Department of Energy  
Washington, DC 20585

On December 14, 1990, the U.S. Department of Energy (DOE) transmitted its responses to the objections, comments, and questions presented in the U.S. Nuclear Regulatory Commission's (NRC) Site Characterization Analysis (SCA) (Reference 1). The NRC staff evaluated these responses, closing some comments and creating open items of the remainder (Reference 2). Two of the items identified as remaining open were comments 42 and 43 which expressed concerns relevant to the topic of erosion.

Enclosures 1 and 2 to this letter summarizes the administrative record with respect to SCA comments 42 and 43 and DOE's basis for resolution of each of these open items. NRC staff also requested additional Yucca Mountain Site Characterization Project documents for evaluation prior to resolution of comment 43.

ENCLOSURE 1

# HOW APPROVED STUDY PLANS RELATE TO EROSION PROGRAM

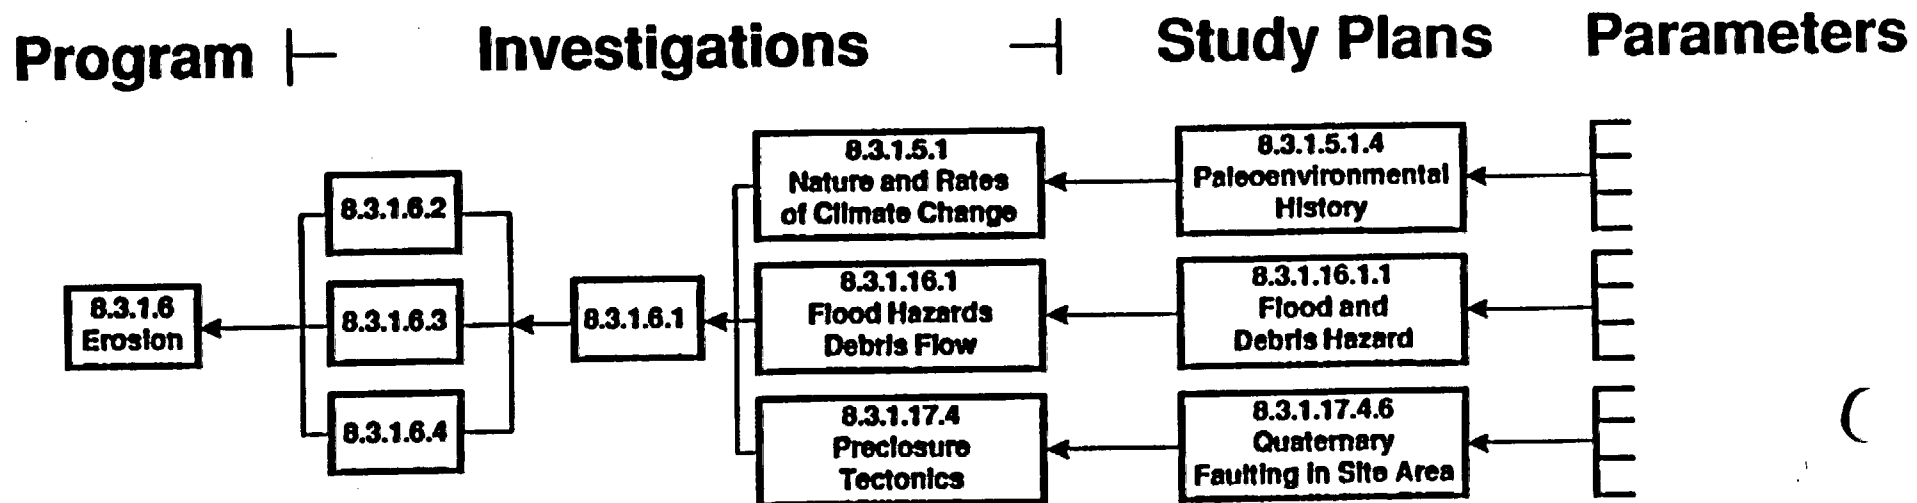
Figure 1 shows how DOE's site characterization studies on erosion were carried out in primarily three ongoing studies. These ongoing studies have been reviewed and accepted by the NRC and include: Study Plan 8.3.1.16.1.1, "Characteristics of Flood Potential of the Yucca Mountain Site," accepted by the NRC in a Phase I review letter dated May 8, 1991; Study Plan 8.3.1.5.1.4, "Analysis of the Paleoenvironmental History of the Yucca Mountain Region," accepted by the NRC in a Phase I review letter dated December 6, 1991; and Study Plan 8.3.1.17.4.6, "Quaternary Faulting in the Site Area," accepted by the NRC in a Phase I review letter dated October 3, 1991. None of these review letters expressed any objections with the studies, but they did have requests for references and other minor concerns to which DOE is preparing separate responses.

SCP Section 8.3.1.6 specified 19 site characterization parameters to be delivered from the four studies (8.3.1.6.1.1, 8.3.1.6.2.1, 8.3.1.6.3.1, and 8.3.1.6.4.1). Study 8.3.1.6.1.1 is the only data-gathering study for erosion in SCP Section 8.3.1.6. Parameters in the other 3 studies are, (1) compiled primarily from other SCP studies, or (2) derived from primary materials generated in other SCP studies. An example of a compiled parameter is parameter 1 of Activity 8.3.1.6.1.1.3, "the absolute ages of the rock varnish coatings of bedrock and surficial deposits", is compiled from work performed to determine the several parameters in Activity 8.3.1.5.1.4.1, "Surficial

This situation arose because early emphasis was placed on gathering site specific data relative to these studies, and as a result, these study plans were developed, approved, and implemented first. The study plans identified above and in Figure 1 provide data for the parameters sought by the erosion studies identified in SCP 8.3.1.6.1.1.3. These study plans provide the details necessary to demonstrate that adequate and sufficient site characterization data has been gathered. The topical report presents the results of these studies and contains the evaluations that were to be made under Section 8.3.1.6.
